# York-Cumberland FEMA appeal Phase I Update

**Wells Town Hall  
May 22, 2018**

Town of Kittery  
Town of Wells  
Town of Kennebunkport  
City of Biddeford  
Town of Old Orchard Beach  
City of Portland  
Town of Harpswell

**RANSOM**  
Consulting  
Engineers  
and Scientists

# Our Proposed SWL

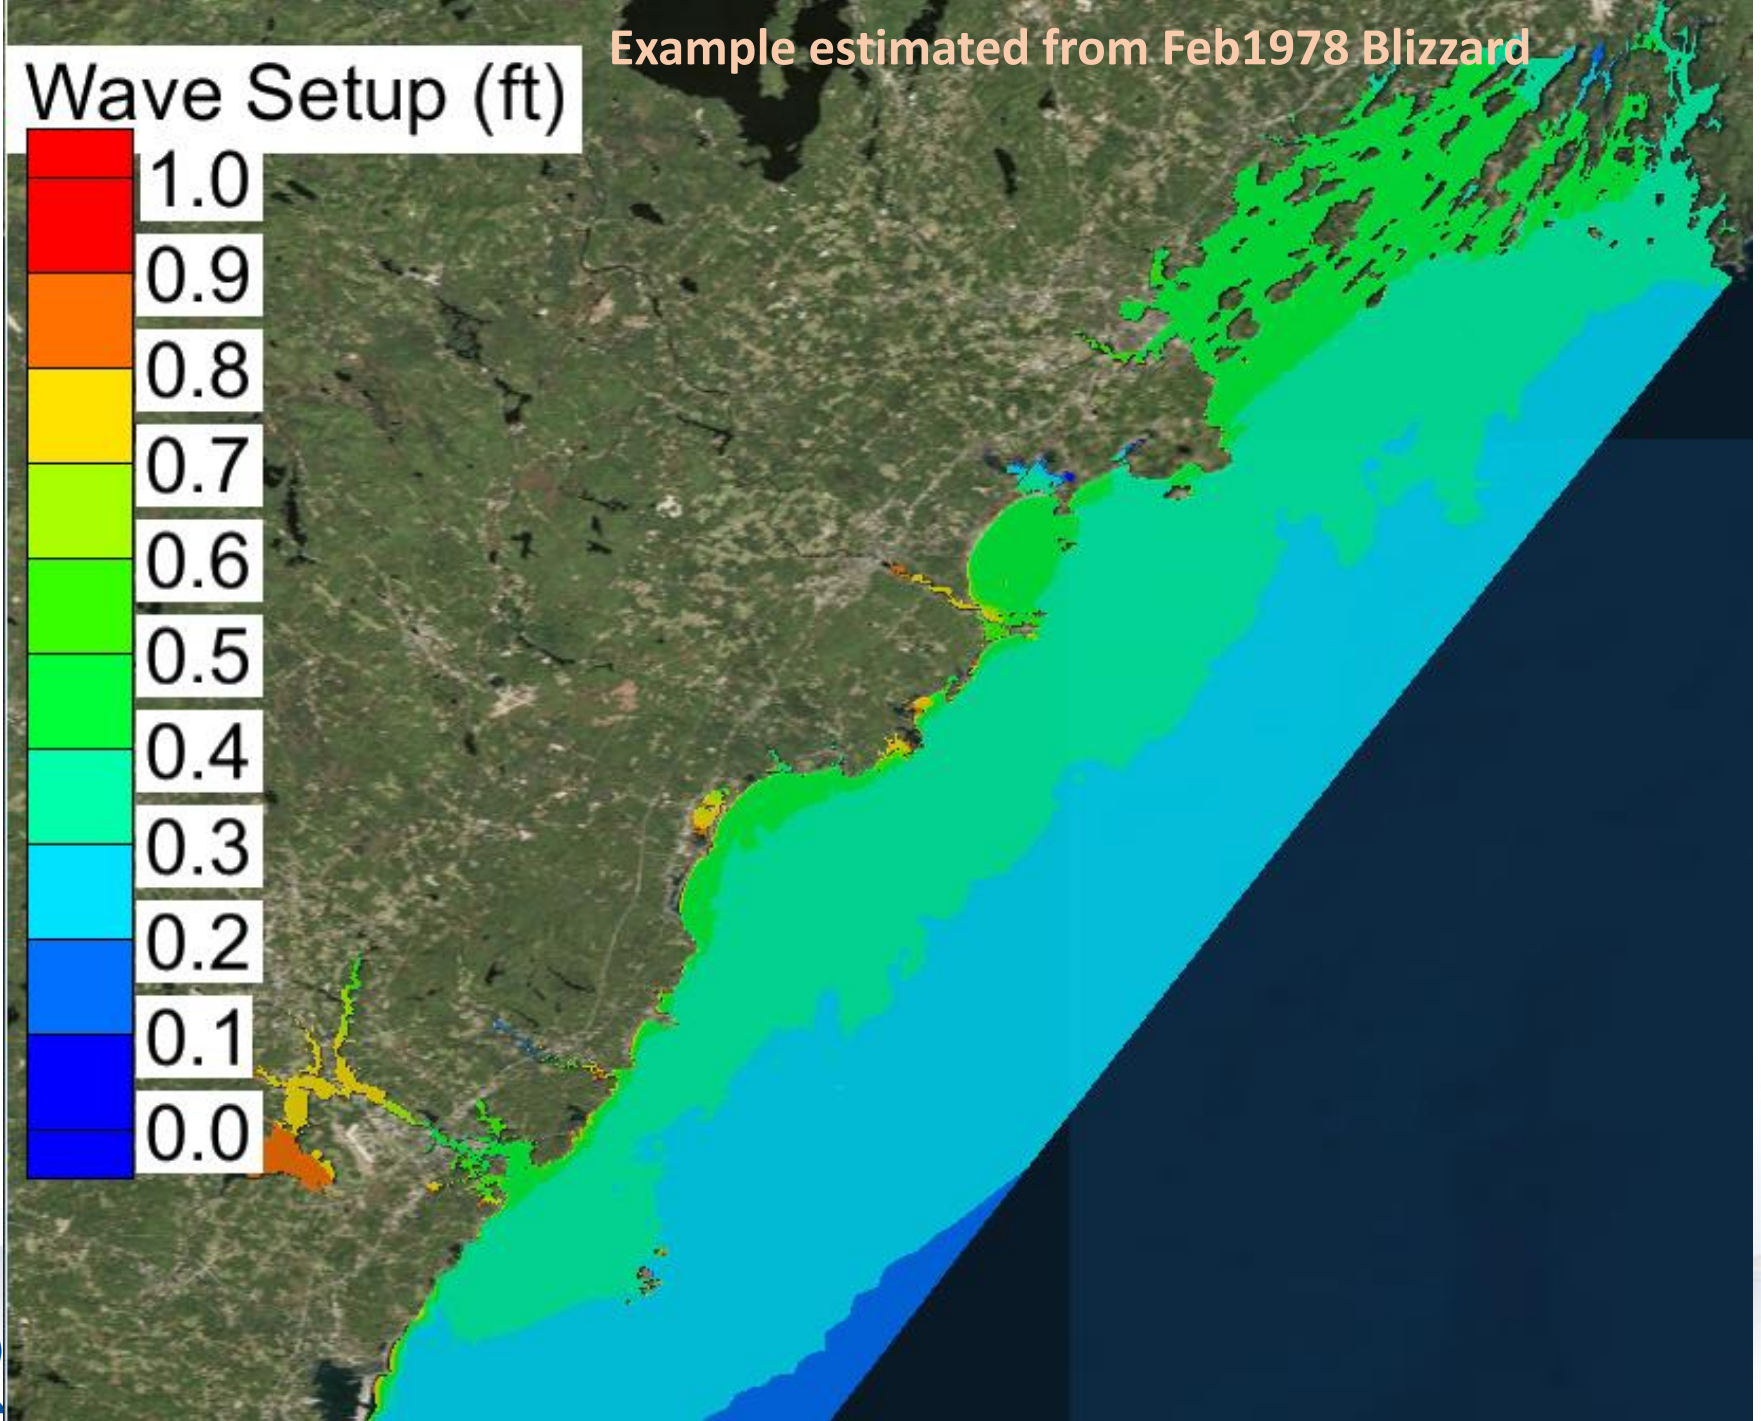
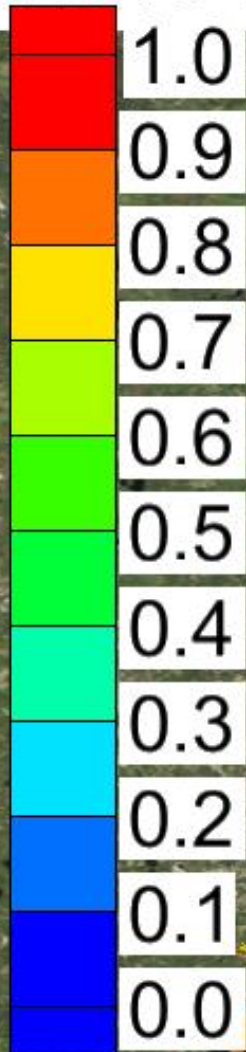
- Using same basic methods as FEMA (e.g. gauge data analysis like OCC did)
- Correct error's in FEMA's analysis
  - Use complete records at Seavey Island and Portland
  - Correct for historic sea level change up to 2017
  - All elevations are in feet-NAVD88

Community	Current Effective FIS	2017 Preliminary FIS (i.e. USACE 1988 Tidal Flood Profiles)	OCC incorrect	Corrected/Updated
Kittery	8.0	9.2	7.8 – 8.0	8.0 – 8.1
Wells	8.9	8.9	NA	NA
Kennebunkport	8.3	8.9	NA	NA
Biddeford	8.2	8.9	NA	NA
Old Orchard Beach	8.3	8.9	NA	NA
Portland	8.6 – 8.9	8.9	8.6 – 9.0	8.4 - 8.6
Harpswell	8.7 - 9.1	9.1	NA	NA

# Kittery 1% annual chance TWL

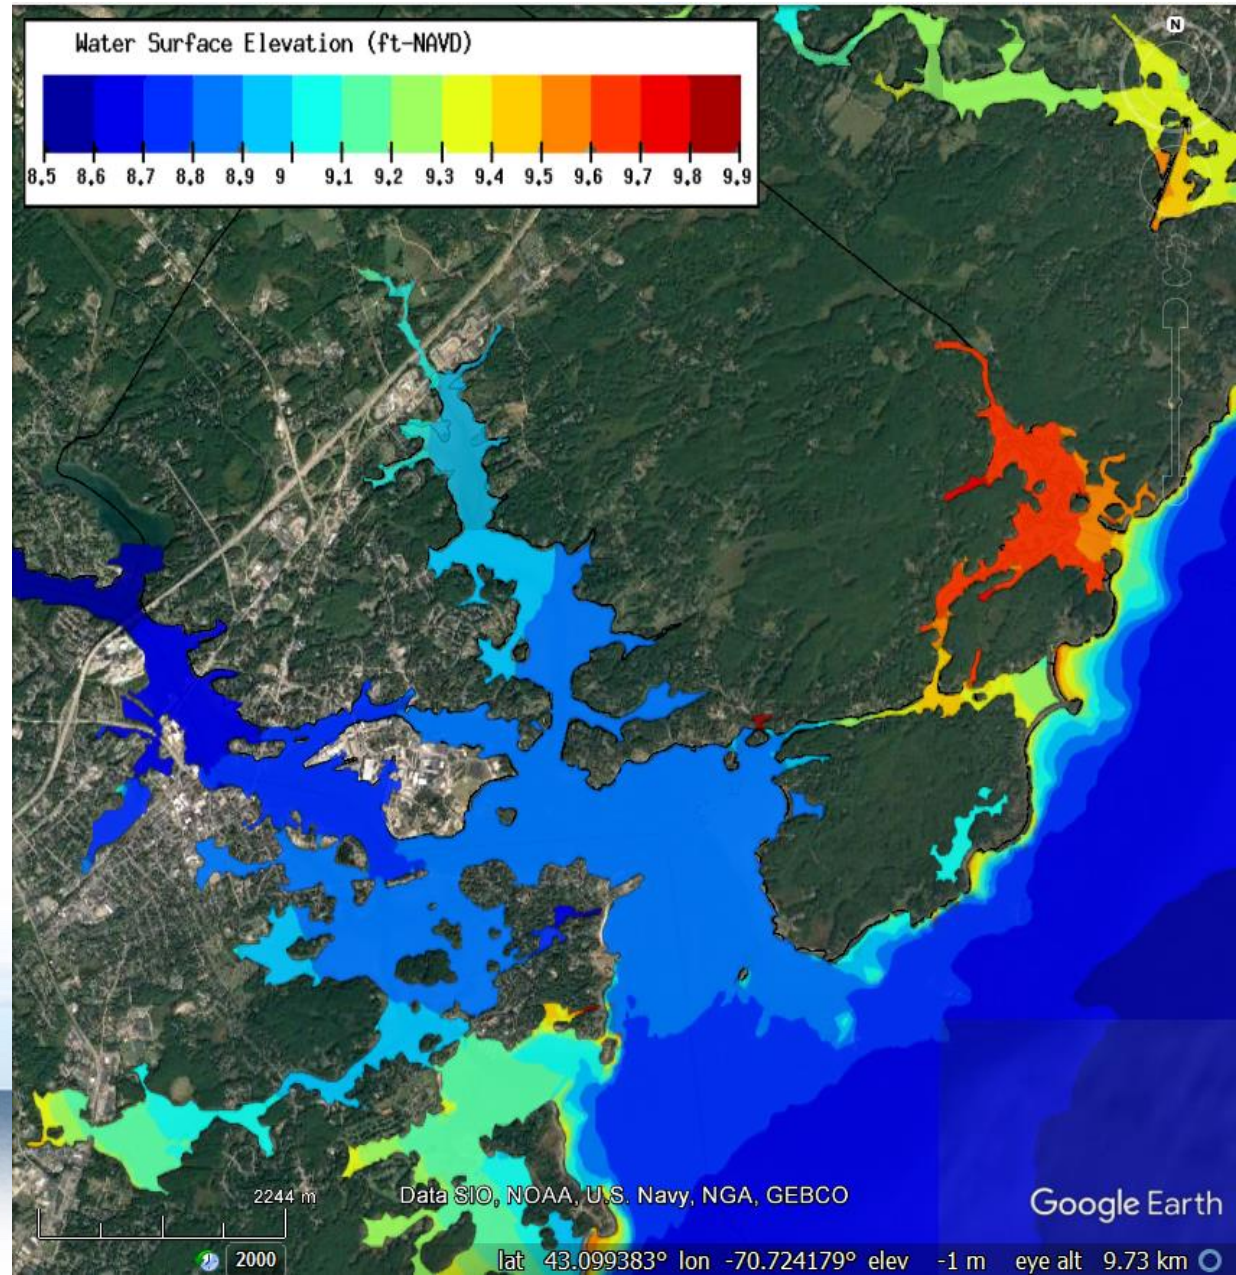
FEMA SWL = 9.2'

Wave Setup = 0.5' to 7.7'

FEMA TWL = 9.7' to 16.9'

# Wells 1% annual chance TWL

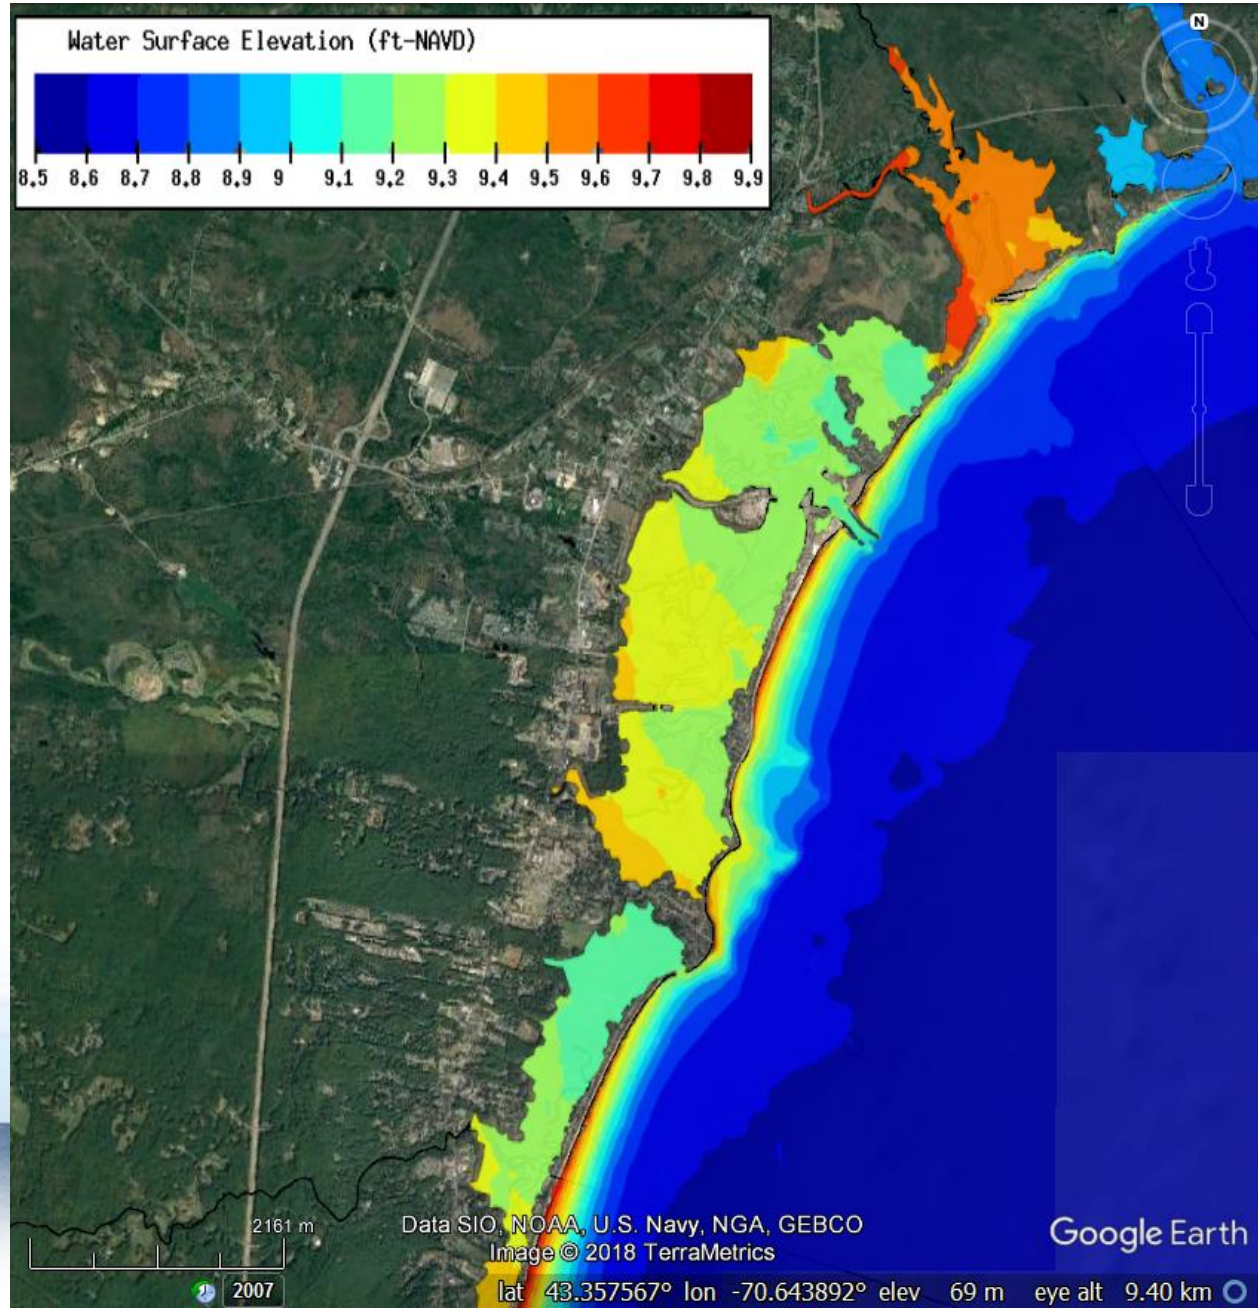
FEMA SWL = 8.9'

Wave Setup = 3.9' to 4.8'

FEMA TWL = 12.8' to 13.7'

# Kennebunkport 1% annual chance TWL

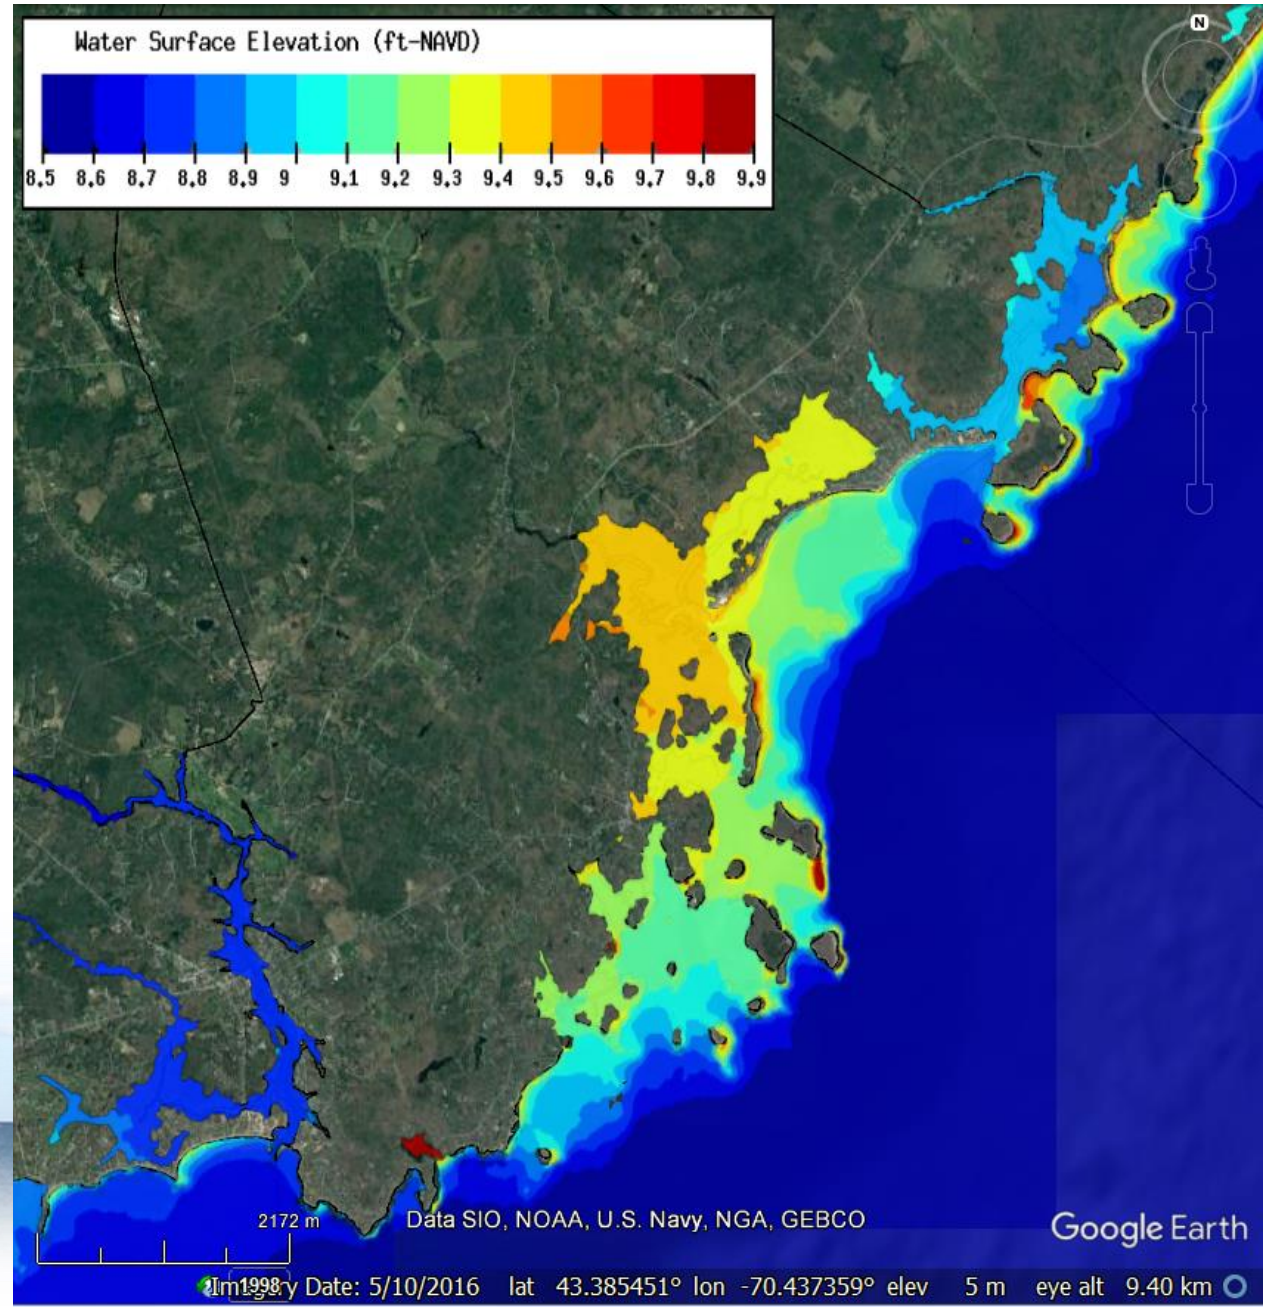
FEMA SWL = 8.9'

Wave Setup = 0.9' to 4.2'

FEMA TWL = 9.8' to 13.1'

# Biddeford 1% annual chance TWL

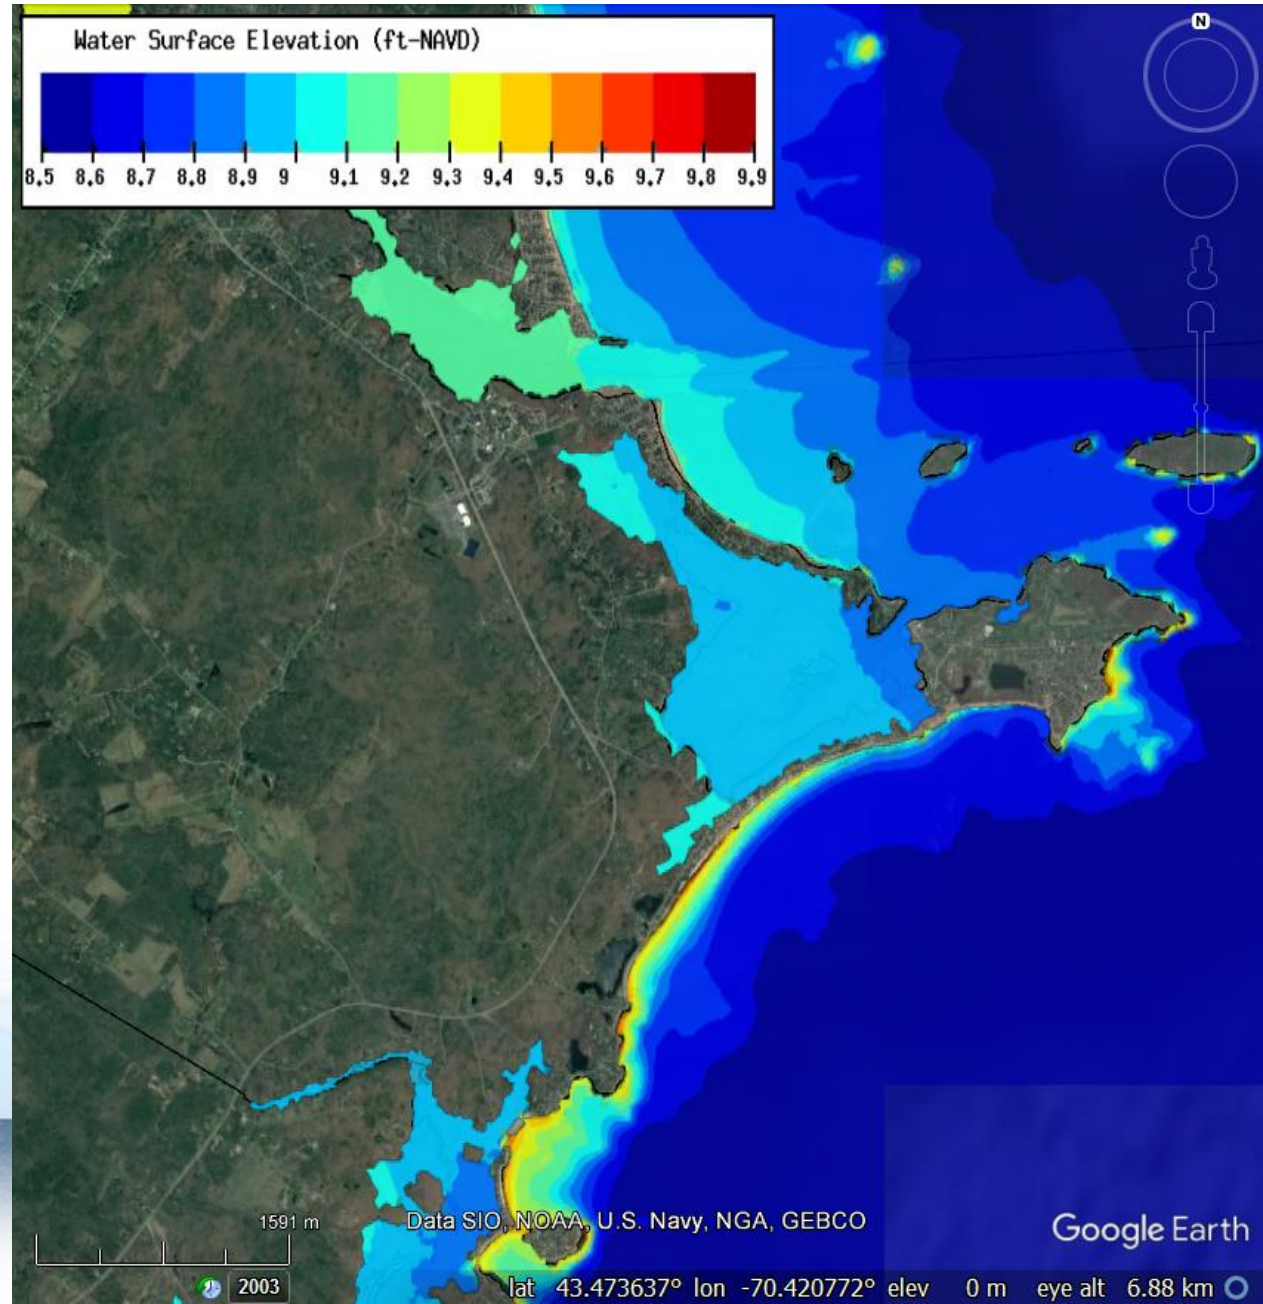
FEMA SWL = 8.9'

Wave Setup = 0.6' to 3.9'

FEMA TWL = 9.5' to 12.8'

# Old Orchard Beach 1% annual chance TWL

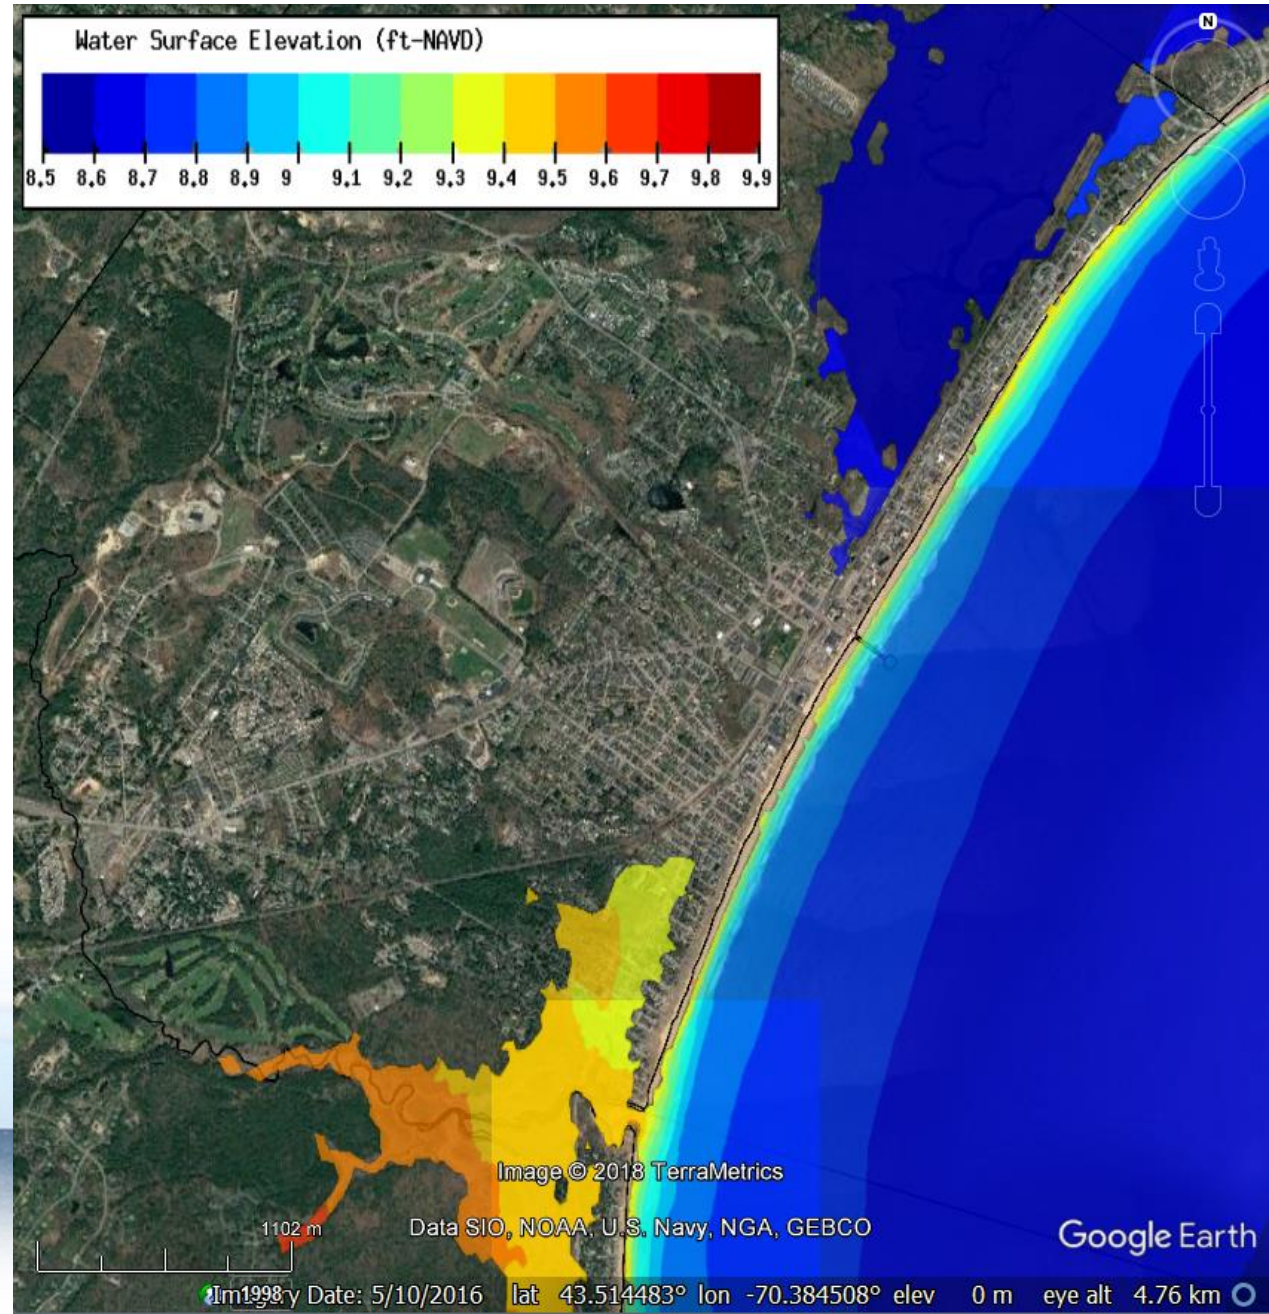
FEMA SWL = 8.9'

Wave Setup = 3.6' to 4.2'

FEMA TWL = 12.5' to 13.1'
